1 Overview

The applicant has lodged a Clause 4.6 variation submission to vary the maximum building height requirement of 80 m under Clause 4.3 of the Blacktown Local Environmental Plan 2015. A copy of the applicant's Clause 4.6 submission is at attachment 6.

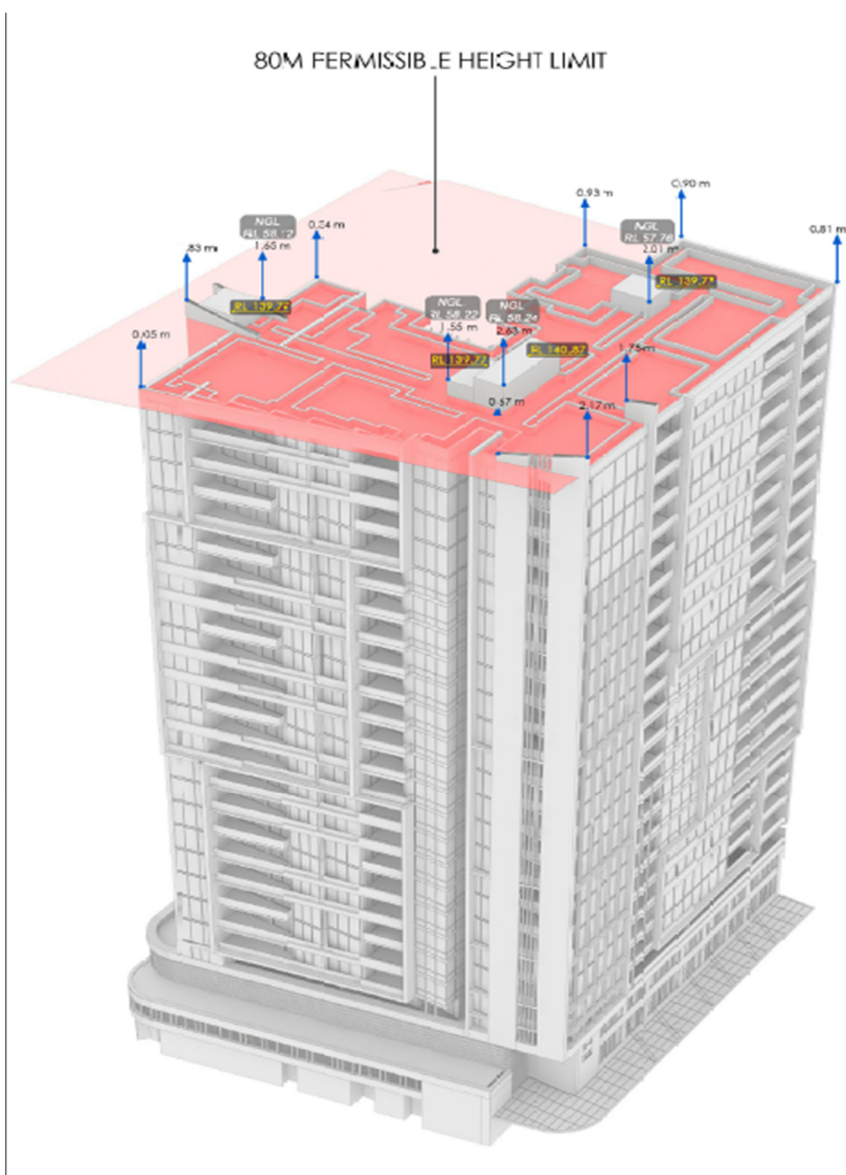
The maximum building height of 80 m under the Blacktown Local Environmental Plan 2015 is varied to achieve a maximum height of 82.63 m (variation 3.29%) specifically to the:

- lift overruns, 82.01 m (variation of 2.51%)
- staircase roof, 82.17 m (variation of 2.71%)
- architectural feature
- building parapet 0.93 m (variation of 1.16%)

as shown below against the 80 m building height plane:

It should be noted that the applicant's Clause 4.6 request has indicated a maximum building height of 81.15 m (variation of 1.4%) to the lift overruns, which is inaccurate to the above findings and the architectural plans.
